SUBMITTAL TRANSMITTAL

WGC Submittal No: 03100-007

PROJECT: **Harold Thompson Regional WRF**
 Birdsell Rd.
 Fountain, CO 80817
 Job No. 2908

SUBJECT: Concrete Placement Sequence - Clarifiers #1 & #2 (SC-1 thru SC-11)

1 SECONDARY CLARIFIER COMPLEX STRUCTURE JOINTING PLAN
 SCALE: 1" = 5'

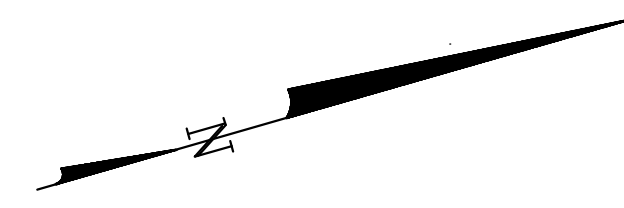
Garney request to make one slab placement with four wall placements per Clarifier. Garney request to use Quadrant points on page SC-3 for wall Construction joints.

Reference Drawing SC-3 for Quadrant points.
